The Commission has issued the enclosed Amendments Nos. 5 and 3 to Facility Operating Licenses Nos. DPR-44 and DPR-56 respectively, for the Peach Bottom Atomic Power Station, Units No. 2 and 3. These amendments include Changes Nos. 6 and 3 respectively and are in response to your request of July 12, 1974.

PEACH BOTTOM ATOMIC POWER STATION, UNIT 2

Amendment No. 5
License No. DPR-44

(CHANGE NO. 6 TO THE TECHNICAL SPECIFICATIONS)

Figure 3.5.1.A

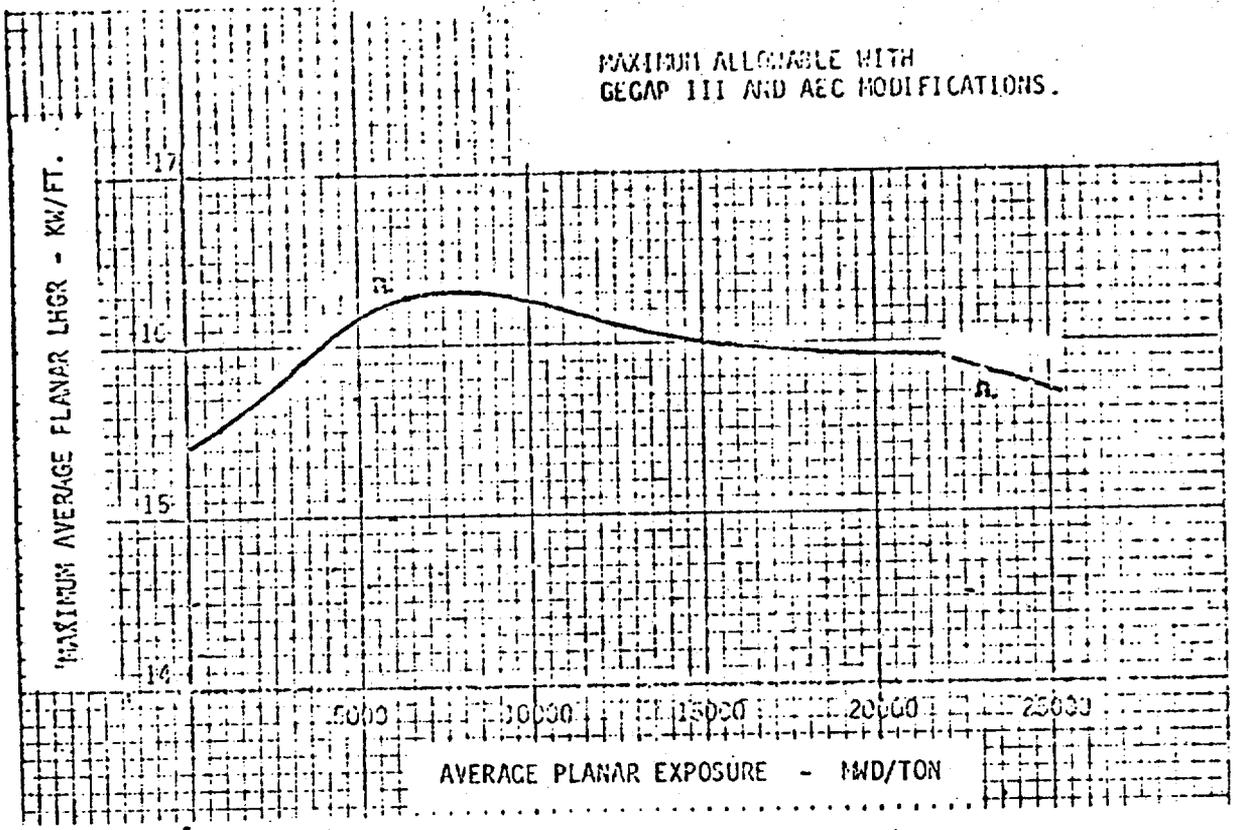
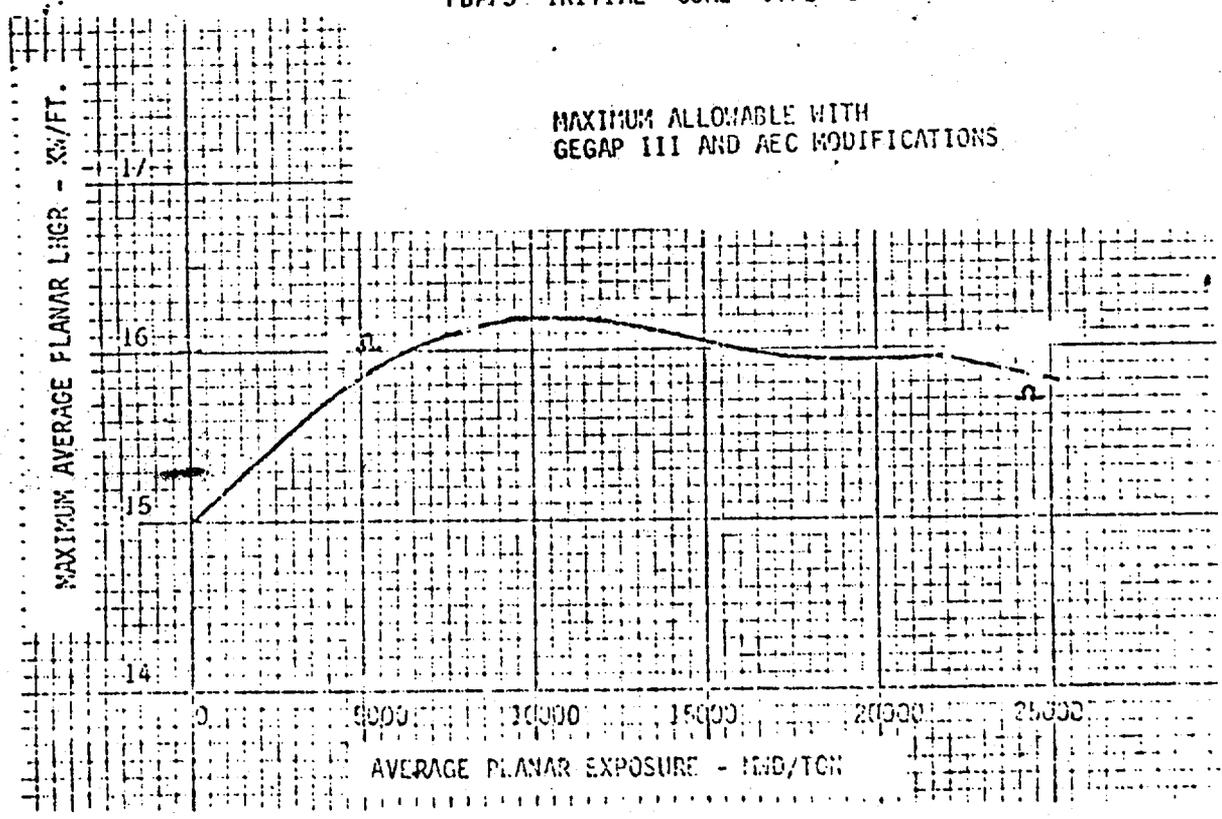
During steady state power operation, the average linear heat generation rate (LHGR) of all the rods in any fuel assembly, as a function of average planar exposure, at any axial location, shall not exceed the maximum average planar LHGR shown in Figure 3.5.1.A or Figure 3.5.1.B.*

The maximum average planar linear heat generation rates shown in Figures 3.5.1.A and 3.5.1.B are based on calculations employing the GEGAP III model described in the General Electric reports NEDO-20181, "GEGAP III, A Model for the Prediction of Pellet-Clad Thermal Conductance in BWR Fuel Rods," November 1973 with related proprietary information provided in NEDC-20181 (Proprietary), November 1973.

FIGURE 3.5.1.B

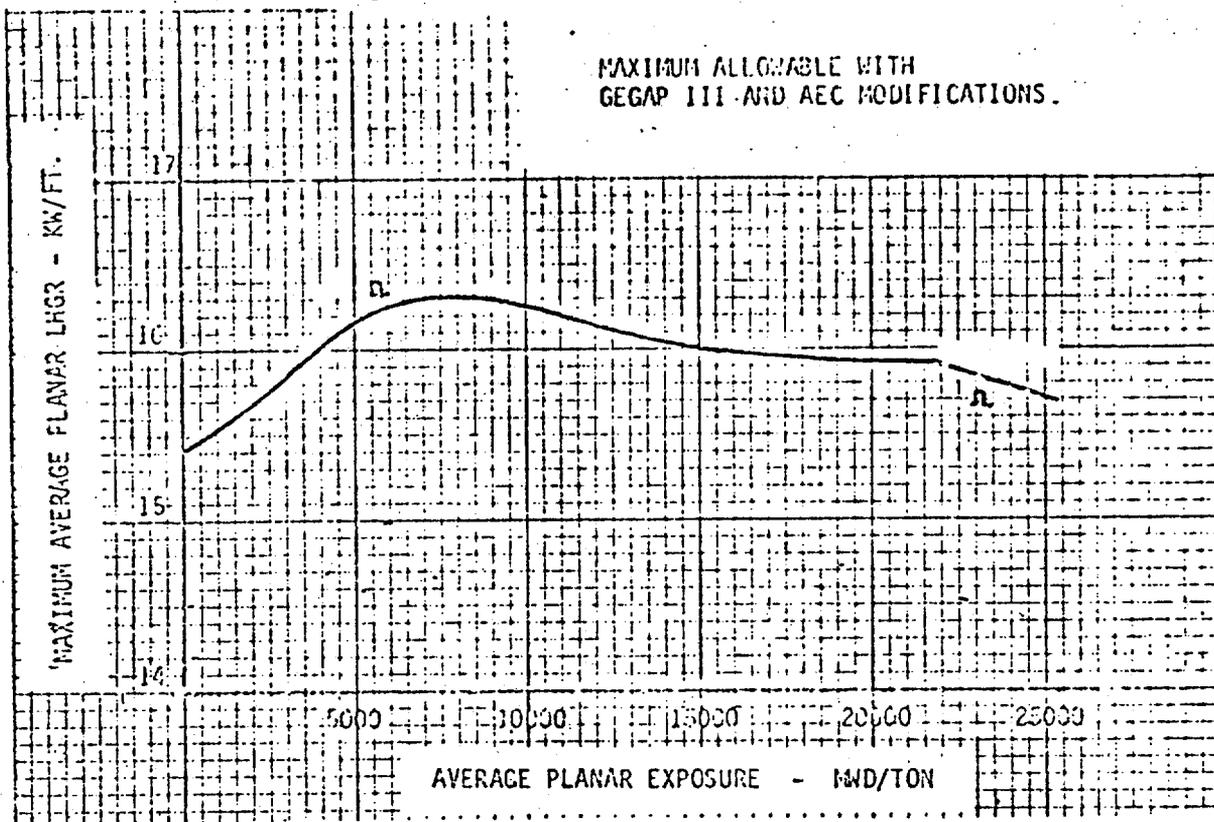
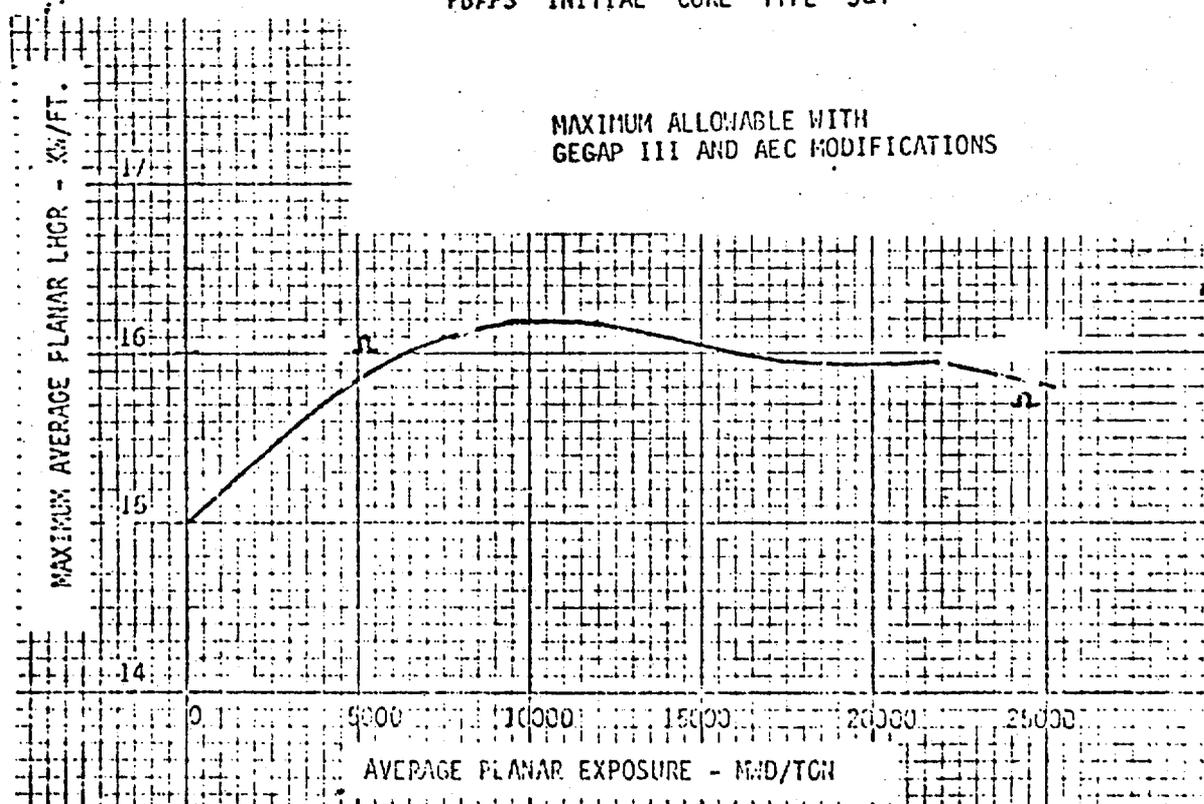
During steady state power operation, the average linear heat generation rate (LHGR) of all the rods in any fuel assembly, as a function of average planar exposure, at any axial location, shall not exceed the maximum average planar LHGR shown in Figure 3.5.1.A or Figure 3.5.1.B.*

The maximum average planar linear heat generation rates shown in Figures 3.5.1.A and 3.5.1.B are based on calculations employing the GEGAP III model described in the General Electric reports NEDO-20181, "GEGAP III, A Model for the Prediction of Pellet-Clad Thermal Conductance in BWR Fuel Rods," November 1973 with related proprietary information provided in NEDC-20181 (Proprietary), November 1973.
